Petition Number: 2025-091

From: Jake Carpenter, PE Reviewer: Chris Manno

Date	Description			
08-28-25	First Review (CM)			
11-20-25	Second Review (CM)

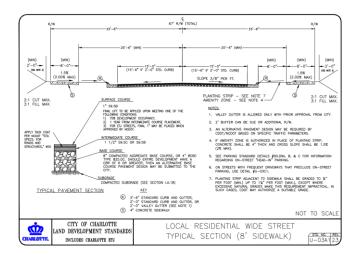
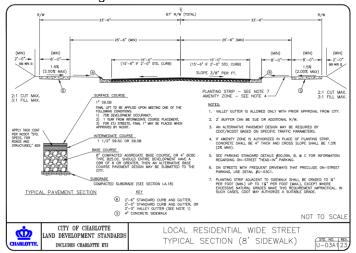
a. Limelight Lane: The future location of the back of curb and gutter is minimum 17.5' from roadway centerline following CLDSM U-03A1 detail.

b. Red Spring Drive: The future location of the back of curb and gutter is minimum 17.5-feet from roadway centerline following CLDSM U-03A1 detail.

Label and dimension the curb and gutter from the centerline for each road on the site plan.

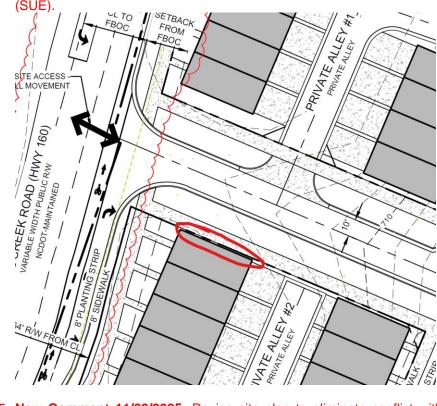
14. **New Comment 11/20/2025:** Show a minimum 2ft ROW or SUE behind sidewalk throughout the site. Make sure no structures or seating areas are located with the Right-of-way or Sidewalk Utility Easement (SUE).

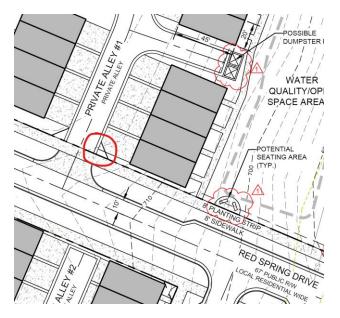
15. **New Comment 11/20/2025:** Revise site plan to eliminate conflict within 10x10 sight triangle. Car parked in driveway is in 10x10 sight triangle for first lot along private alley #1.
